# Master Sign Plan

## 15-099MSP – BSD Scioto River Neighborhood District

### Bridge Park B & C Blocks – Riverside Drive

#### Window Sign

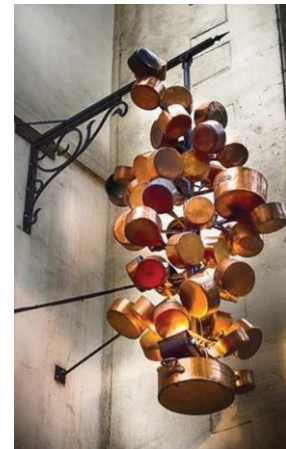
These are graphics attached or applied directly to interior surface of the window, including metal leaf, vinyl, painted, edged-cut, and sandblasted lettering. These also include Building Identification Signs per Code. The MSP does not require window signs to be counted as one of the permitted signs.
